NRC Staff Evaluation of the Next Generation Attenuation for Central and Eastern North America Project (NGA-EAST) Ground Motion Model Characterization

Date Published: September 2020

FOREWORD

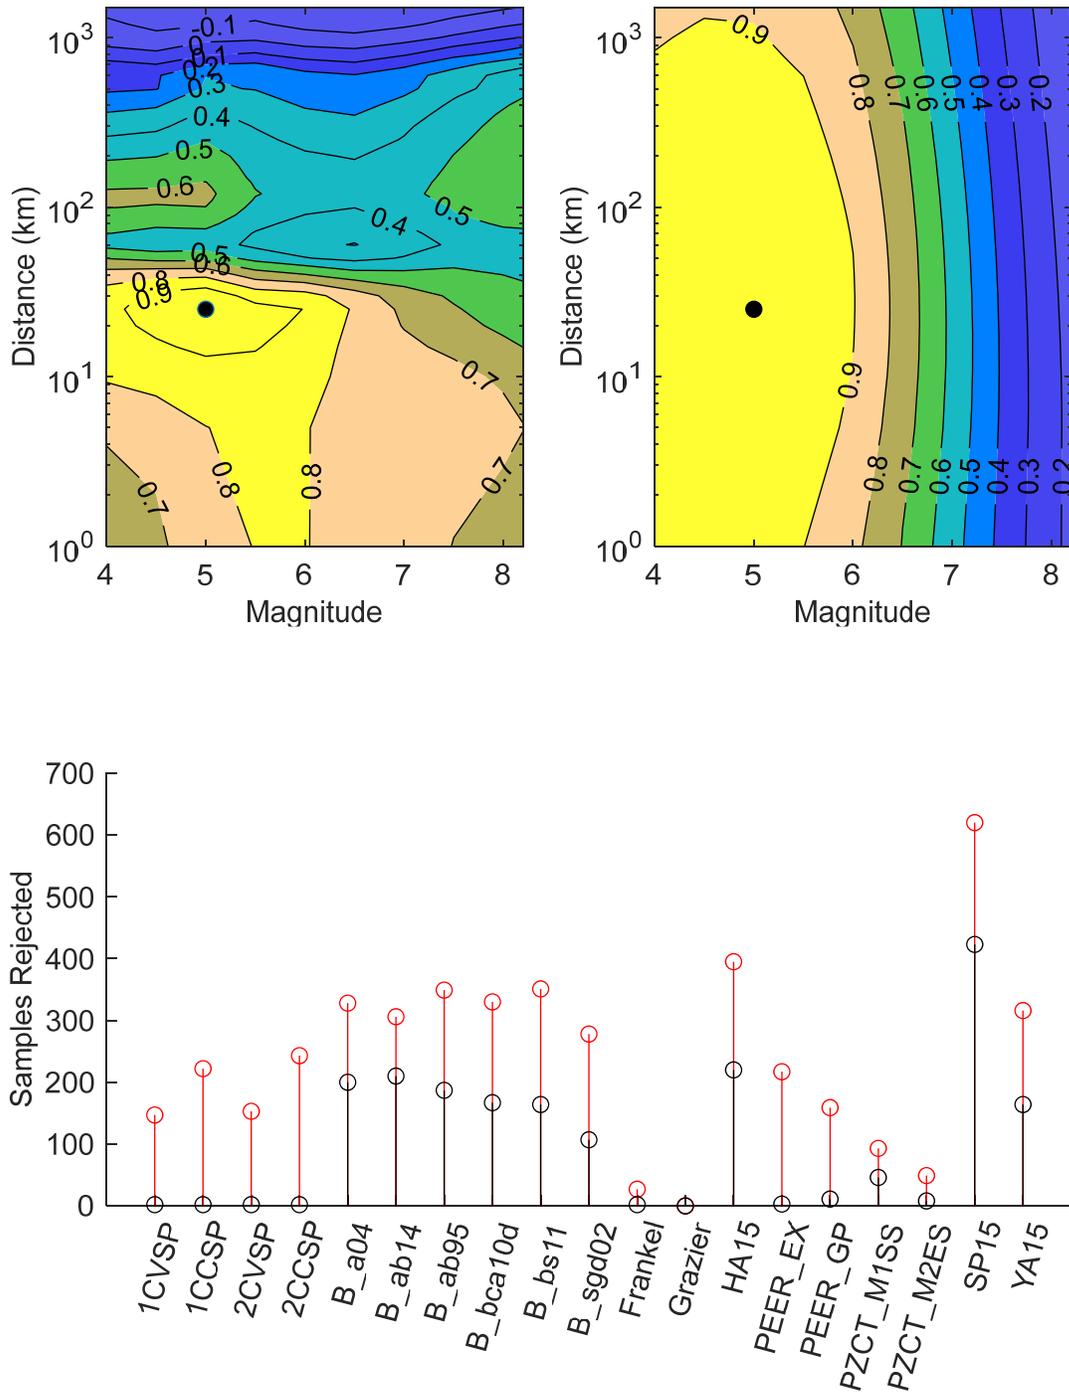
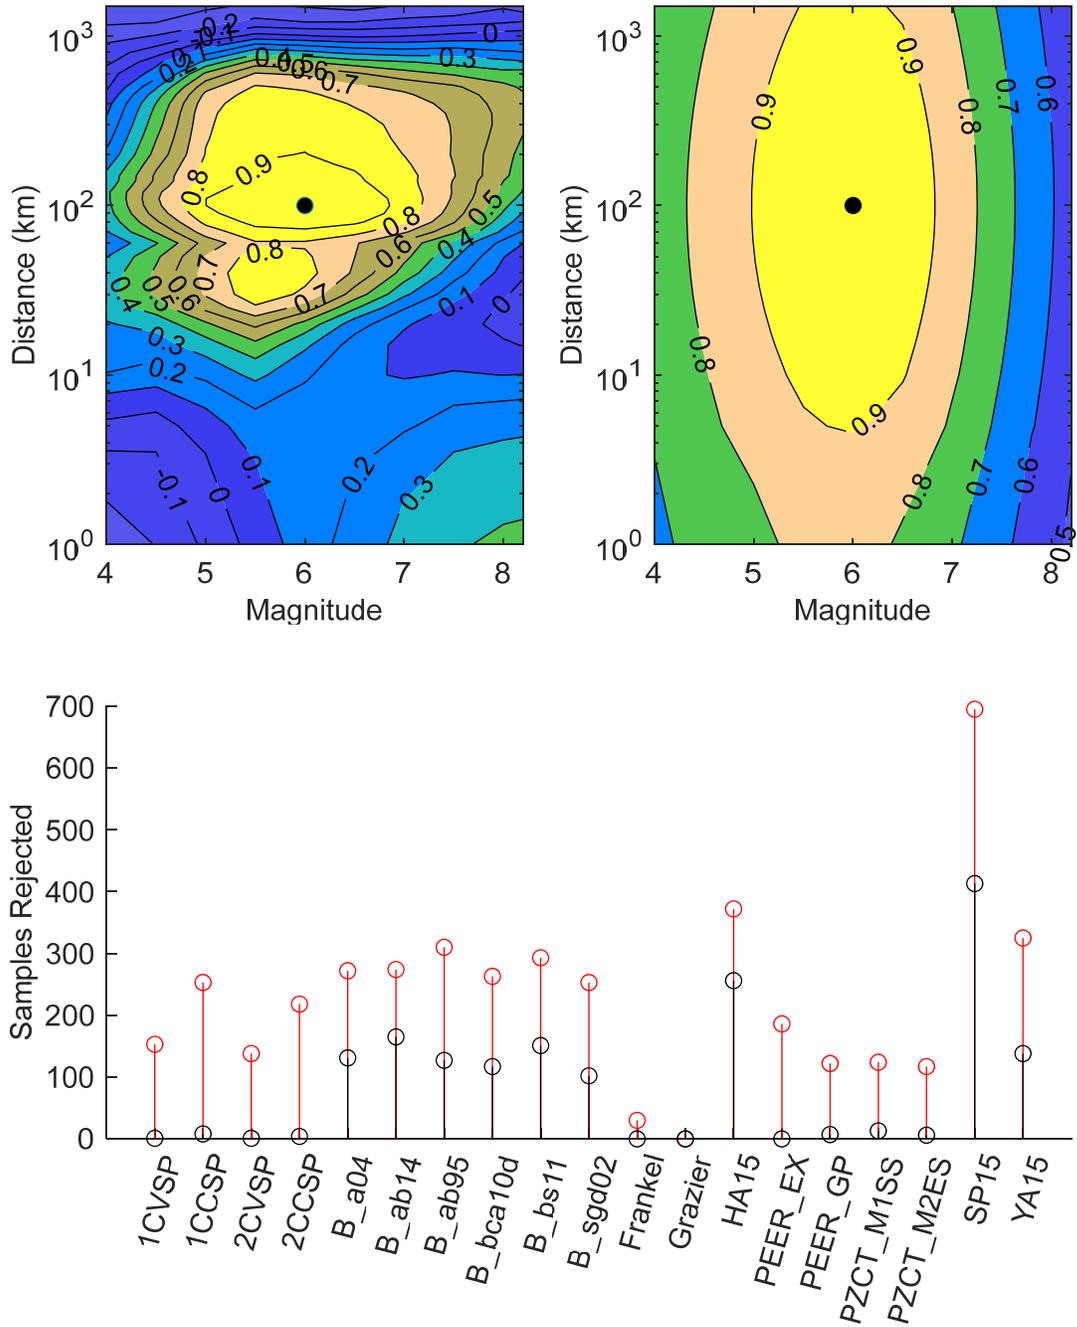
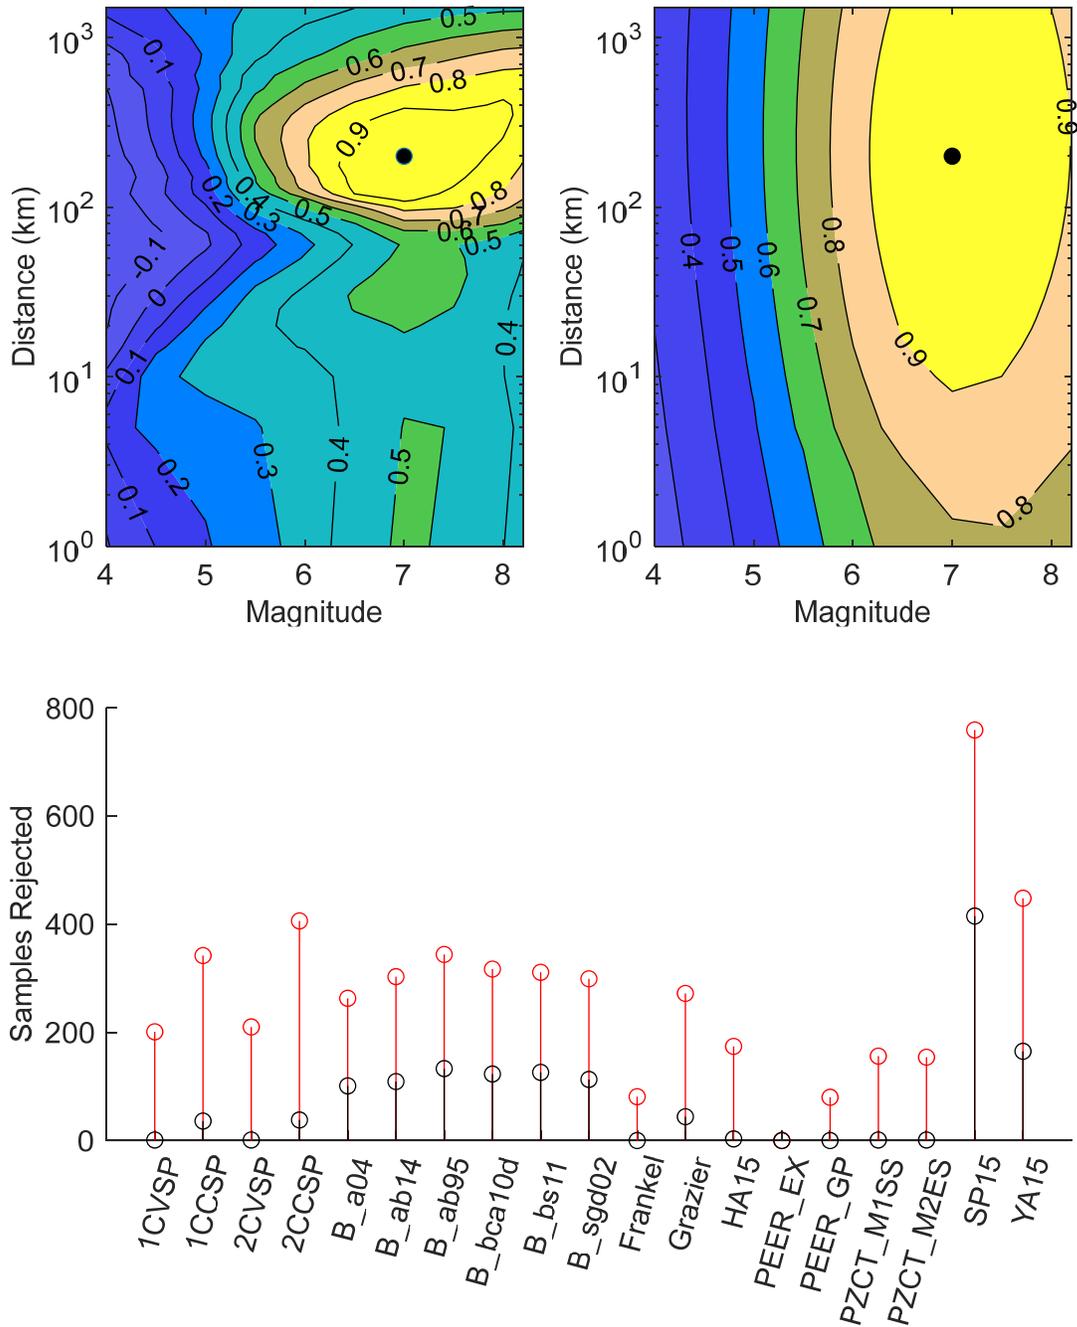
1. A significantly larger number of generated models are rejected due to not meeting the physicality constraints established by the TI team and described in Section 8.3.2 of NGA-East. Figure 5.1-Figure 5.3 (bottom) show how implementing a Gaussian process regression to the correlation model can greatly reduce the number of models being rejected.
2. A narrowing of the ground motion distribution can occur due to lack of physically realistic models being sampled from the tails of distribution.

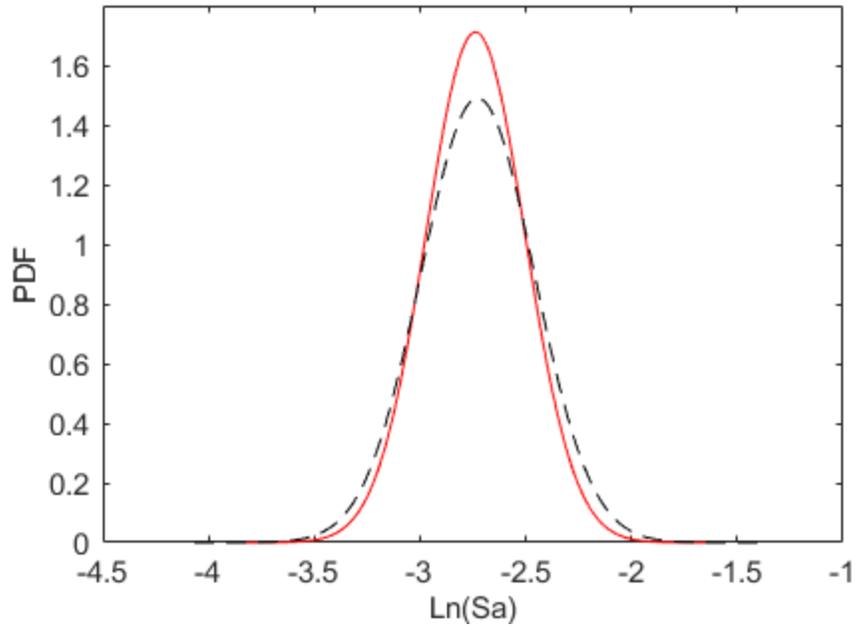
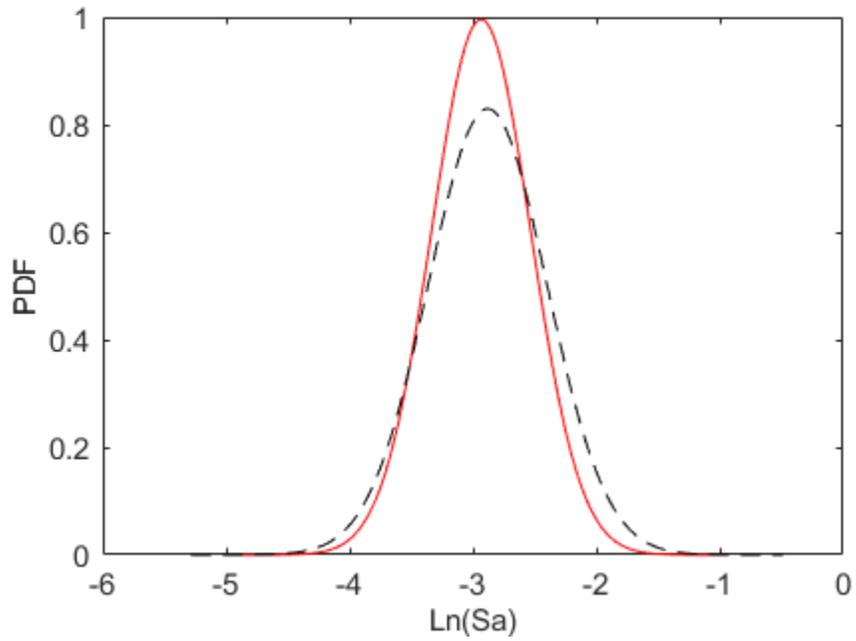
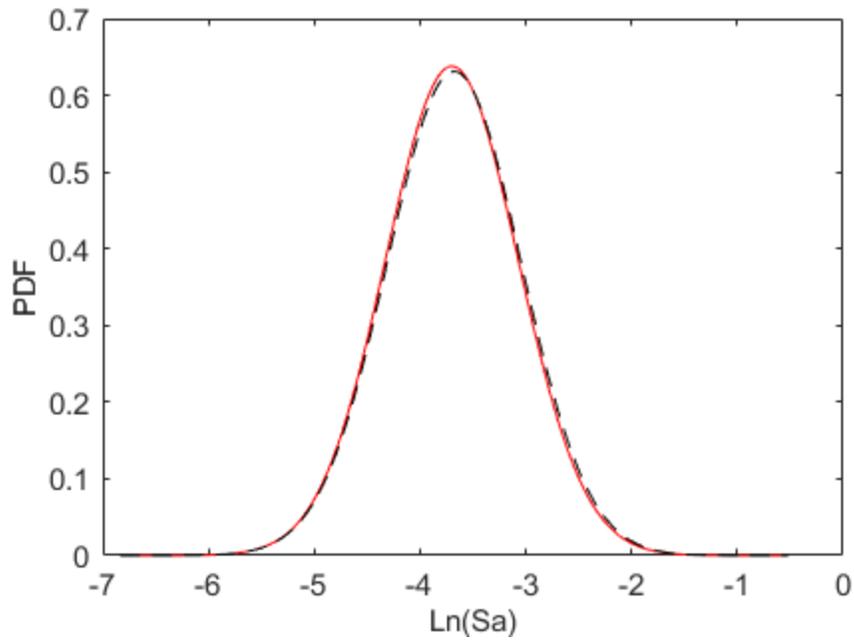
What was not clear to RES staff, is whether implementing GP regression on the seed GMM correlation results in a distribution of ground motions consistent with the seed models. Therefore, sensitivity analyses were performed by the RES staff to determine the appropriateness of the GP regression correlation model by comparing the resulting ground motion distributions of the seed GMM correlation model and the GP regressed correlation model. The resulting ground motion distributions using the models in Figure 5.1 - Figure 5.3 are shown in Figure 5.4 - Figure 5.6. No significant change in the mean of the distributions occurs between correlation models; however, there is a slight increase in the variance using the GP regressed correlation model. The increase in variance can be explained by the fact that the GP regressed model is smoother with changes in magnitude and distance. Thus, models generated from samples drawn near the tails of the distribution are more likely to produce physically reliable models. Similar results were found for all magnitude and distance scenarios across all seismic hazard frequencies. As a result, the staff concludes that the TI team's use of Gaussian process regression not only produces ground motion distributions consistent with the seed models but also allows for a broader range of the epistemic uncertainty in ground motion estimates to be captured.

RES Staff expressed concern with the Gaussian Process regression used to smooth the ground motion correlation that informs the selection of the median models. Sensitivity analyses were performed by RES Staff to compare the resulting ground motion distributions from both the seed and GP regressed correlation models. The results show that the GP regression approach used by the TI Team is an effective approach for sampling the ground motion space while preserving the ground motion distribution associated with the seed GMMs (Section 4.1).

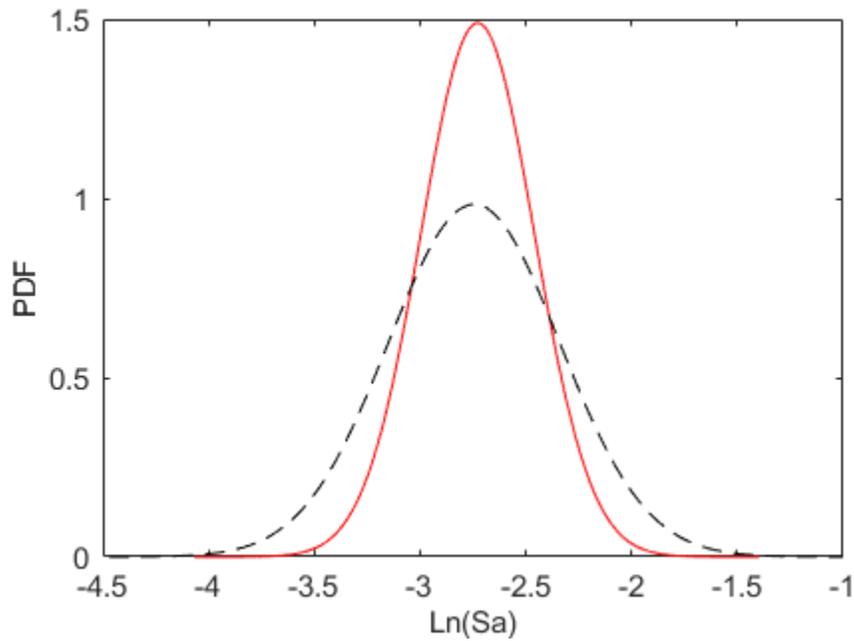
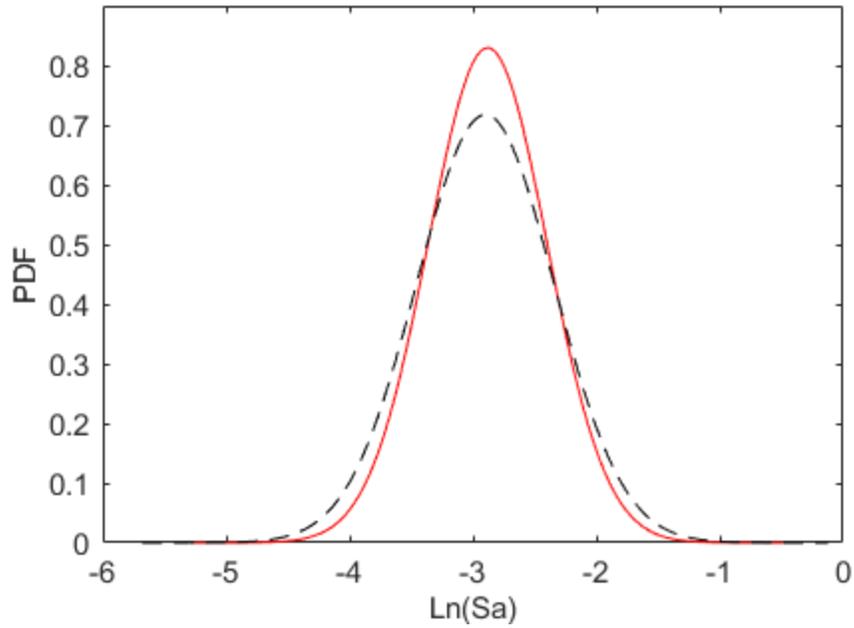
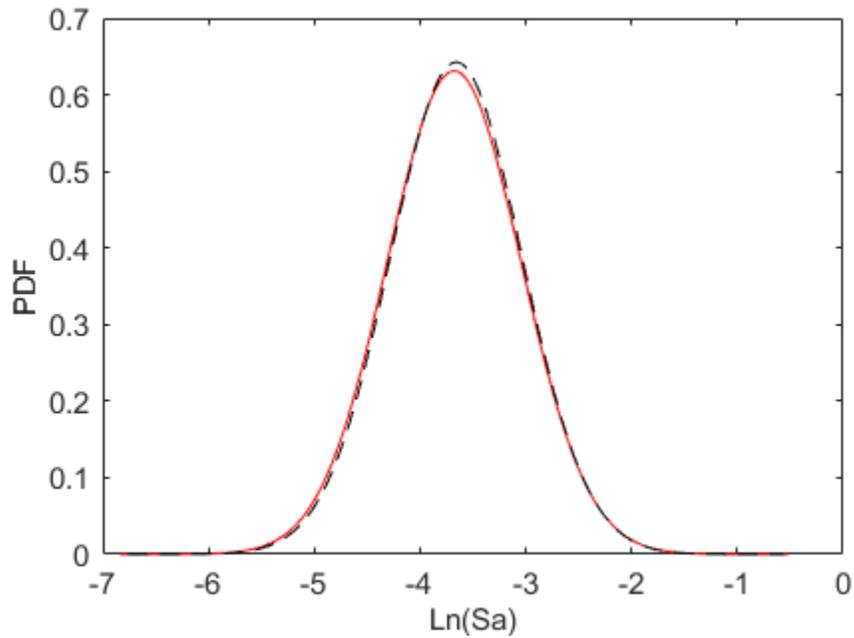
Therefore, RES staff performed sensitivity analyses by truncating the maximum R_{RUP} distance to 800 km and comparing the resulting ground motion distributions to those of the NGA-East maximum R_{RUP} distance of 1500 km. The results show an increase in the variability for the M 5, R_{RUP} 25 km scenario with the increased variability diminishing with larger R_{RUP} as shown in Figure 5.7-Figure 5.9. The increase in variability with a decrease in R_{RUP} is consistent across all M and most pronounce for small magnitudes ≤ 5 . This effect can be explained by the combination of a reduction in the number of dimensions sampled and the sparseness of ground motions for larger R_{RUP} . The truncation of R_{RUP} results in a multivariate distribution of ground motion with 33 less dimensions to be sampled. This reduction allows for a more refined sampling of the ground motion space that is coupled by higher resolution of ground motions at shorter R_{RUP} . RES staff considered the above results and concluded that there would be essentially no impact on the final mean hazard from decreasing the maximum R_{RUP} distance to 800 km. In addition, because only a limited number of the total M and R_{RUP} scenarios are affected, there will be no significant effects on the resulting epistemic uncertainty in the median ground motions.

RES Staff also expressed concern with the maximum R_{RUP} distance of 1500 km used in the NGA-East GMC compared to shorter distances typically used in PSHAs. The TI team selected the larger distance to account for regions of low seismicity where larger-distant events control hazard. Sensitivity analyses performed by RES Staff compared the ground motion distributions from both the NGA-East GMC model, which uses a maximum R_{RUP} distance of 1500 km, and an alternative GMC model with a maximum R_{RUP} distance of 800 km. The results show that the reduction in the maximum R_{RUP} produces a small increase in ground motion variability for small magnitudes at short distances; however, RES Staff concludes that there would be essentially no impact on the mean hazard since only a limited number of the total M and R_{RUP} scenarios are effected (Section 4.2). Therefore, RES Staff concludes that the NGA-East GMC model is appropriate for regions of both high and low seismicity and that the maximum R_{RUP} distance of 1500 km is not an issue.

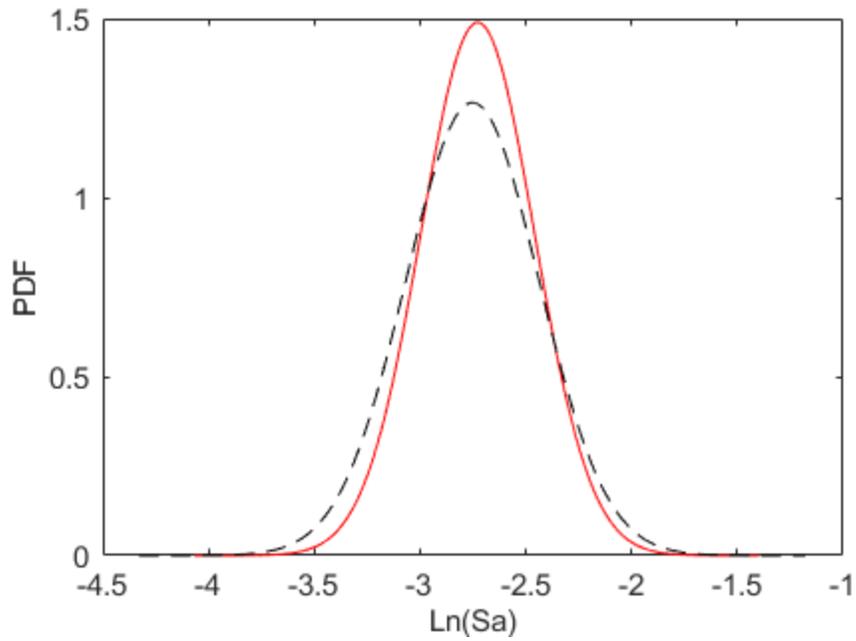
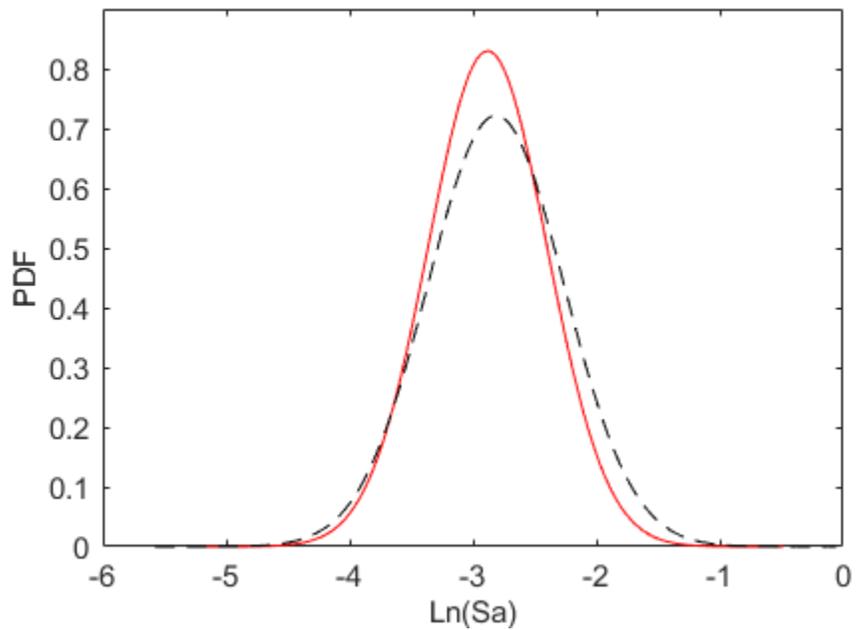
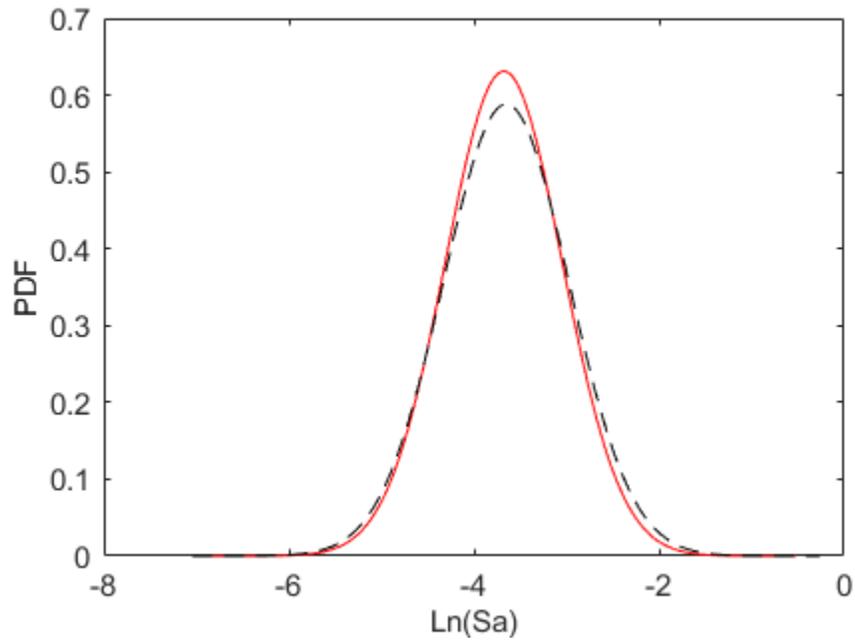
Figure 5.10 - Figure 5.12 compare the resulting ground motion distributions from both the NGA-East model and the alternative GMC model described above. The results show the distribution of ground motion resulting from the alternative GMC model to be only slightly different from that of the NGA-East model with no significant change in the mean or standard deviation. Similar results were found for all magnitude and distance scenarios across all hazard significant frequencies. As a result, RES Staff is confident in the regulatory stability of the NGA-East GMC for use in future PSHAs for nuclear power plants.
